ADDENDUM 1 – JOB 24

TO: All prospective bidders on project NHU-4-083(128)197, Job No. 24 scheduled for the May 13, 2016 bid opening.

Project: NHU-4-083(128)197 (PCN-20600)

Mill & Overlay
US Hwy 83
S Urban Limits to 20th Ave SW
Minot, ND

Curb & Gutter - Type 1 Special Detail

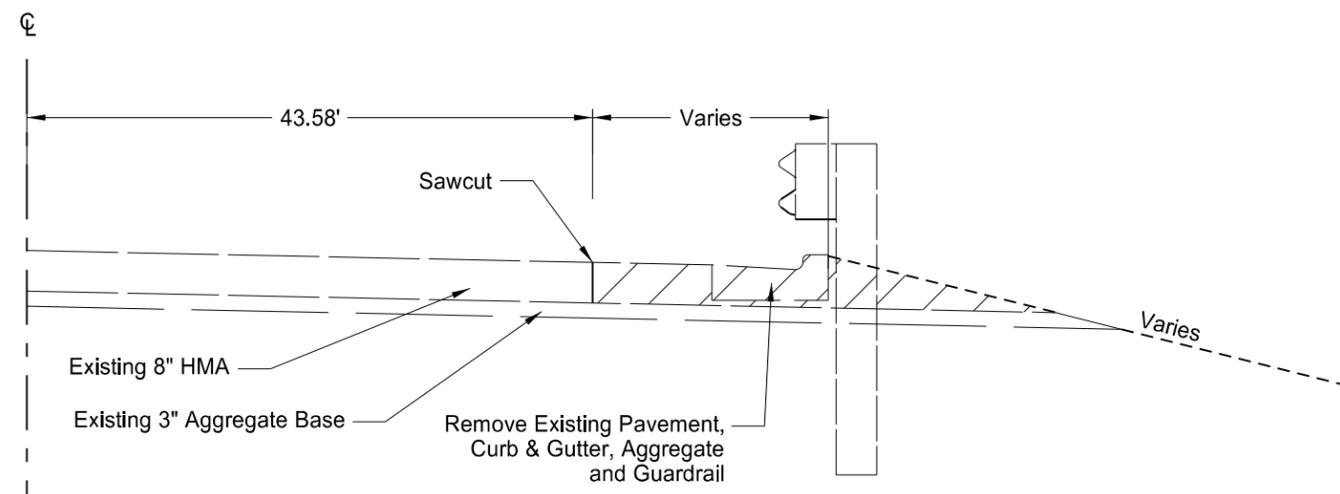
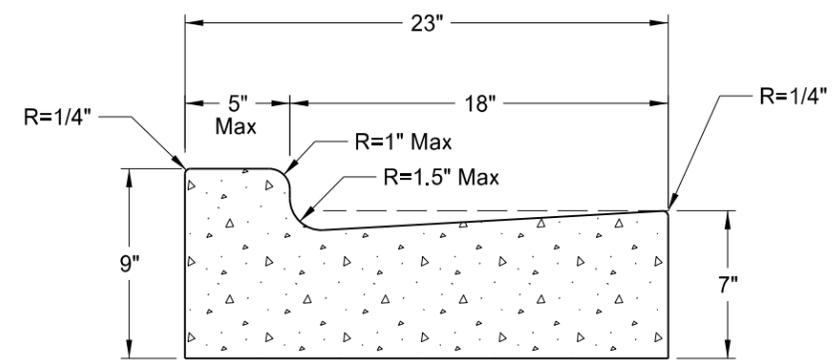
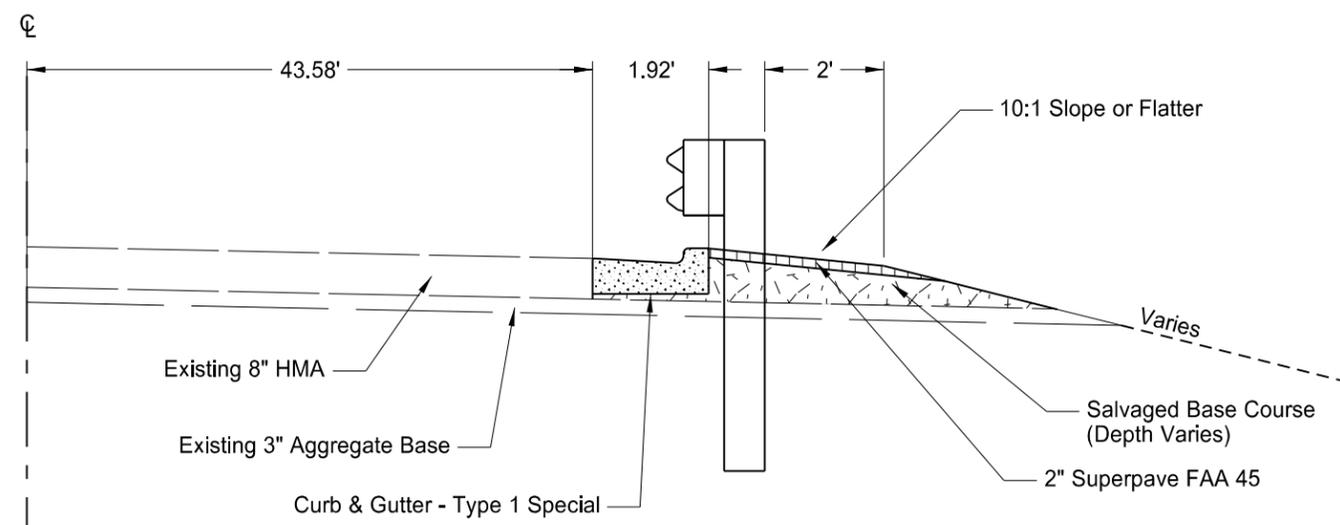
Sheet 3:

- Added sheet for Curb & Gutter Detail

Thrie/W-Beam Guardrail Layout At Bridge Ends
 Br. No. 0002-146.366
 Mill & Overlay
 US Hwy 83
 S Urban Limits to 20th Ave SW
 Minot, ND

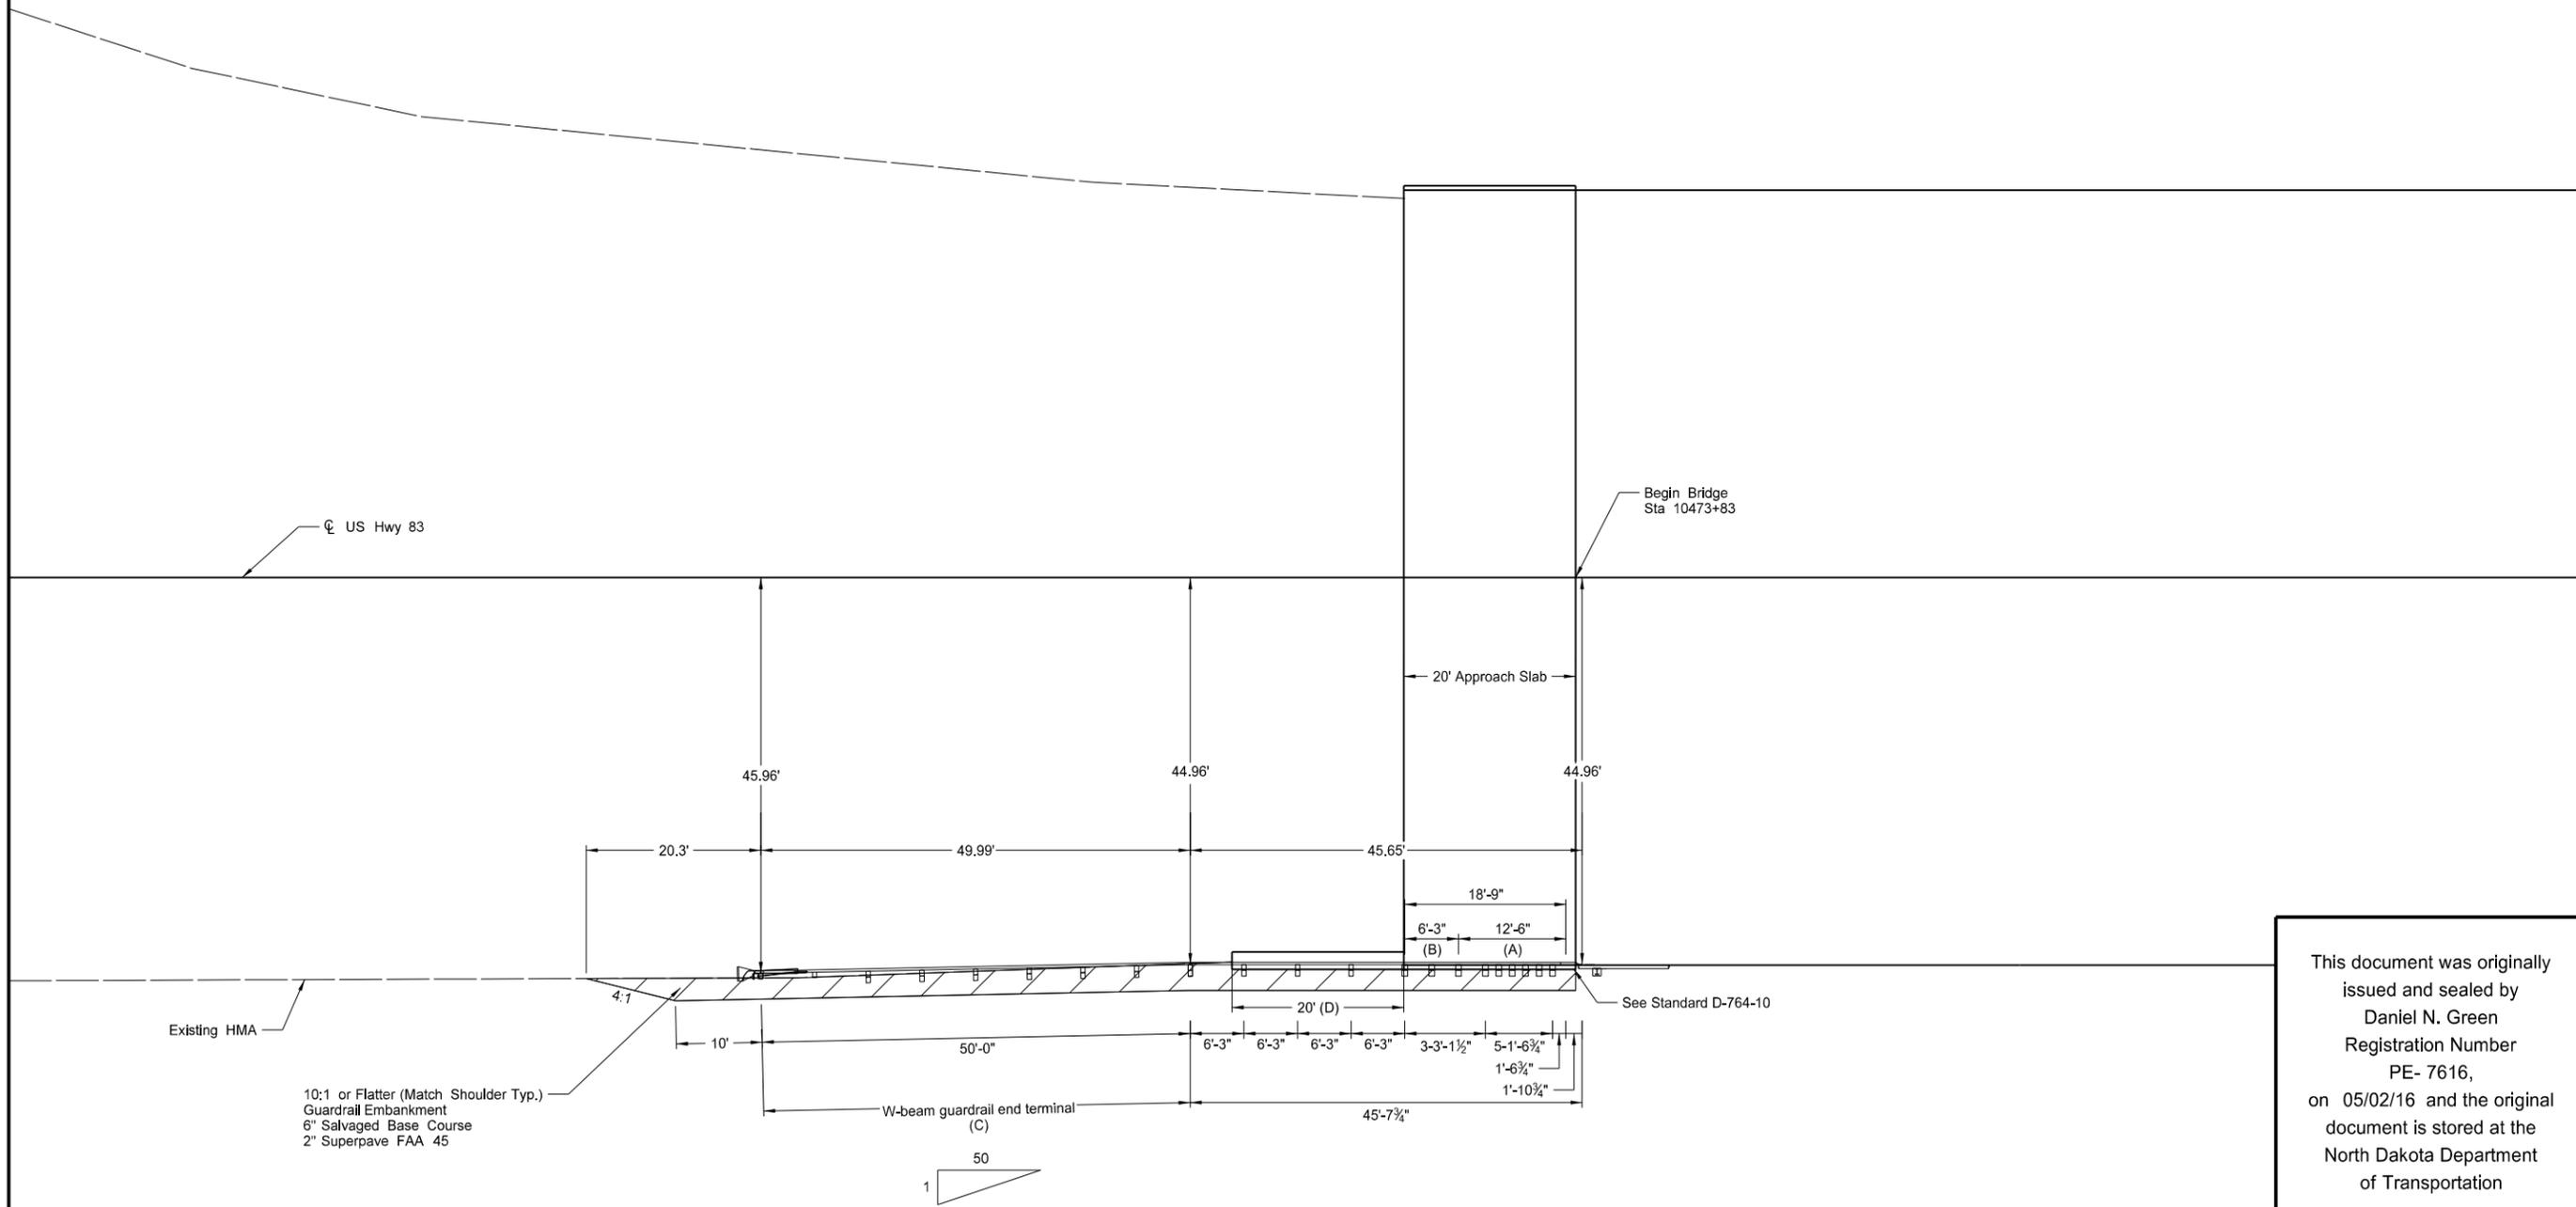
Sheet 1:

- Added sheet for Guardrail Layout at Bridge Ends

Thrie/W-Beam Guardrail Layout At Bridge Ends
Br. No. 0002-146.366
Mill & Overlay
US Hwy 83
S Urban Limits to 20th Ave SW
Minot, ND

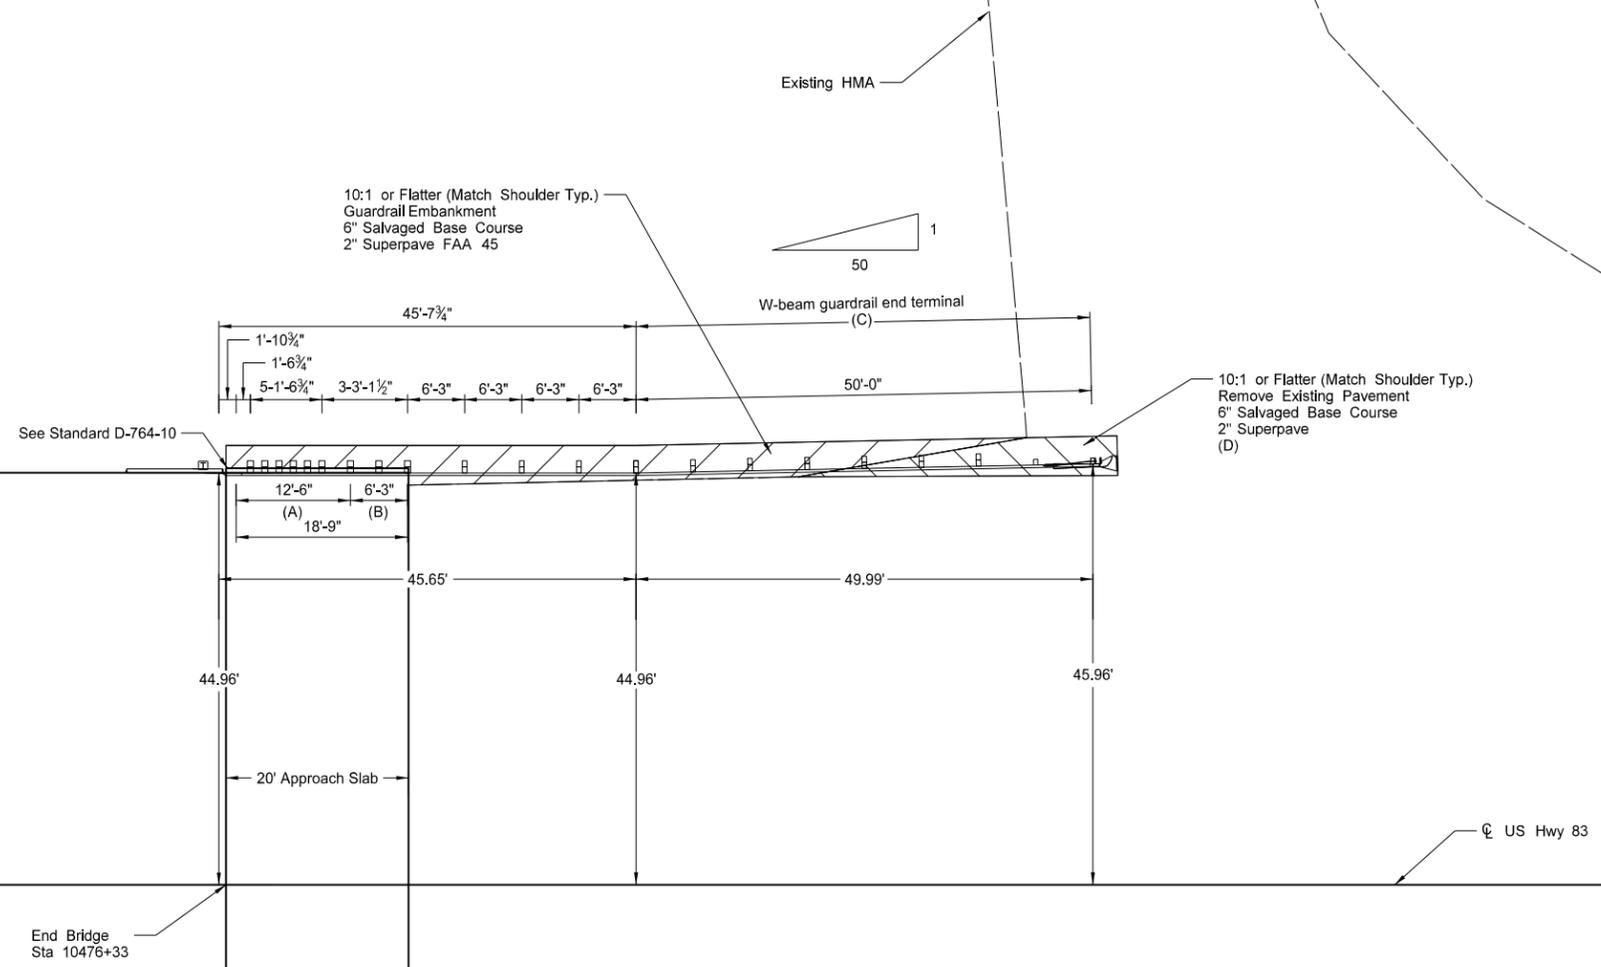
Sheet 2:

- Added sheet for Guardrail Layout at Bridge Ends

Thrie/W-Beam Guardrail Quantities

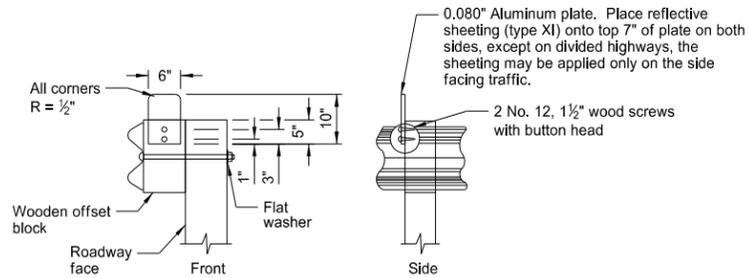
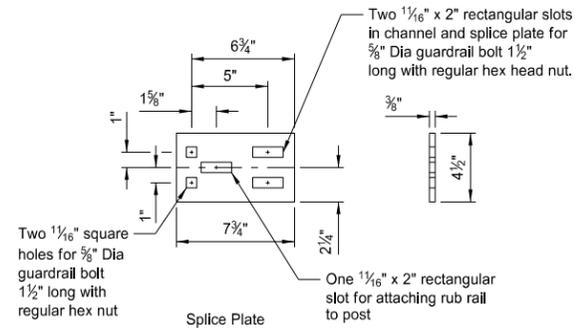
Sheet 3:

- Added sheet for Guardrail Quantities
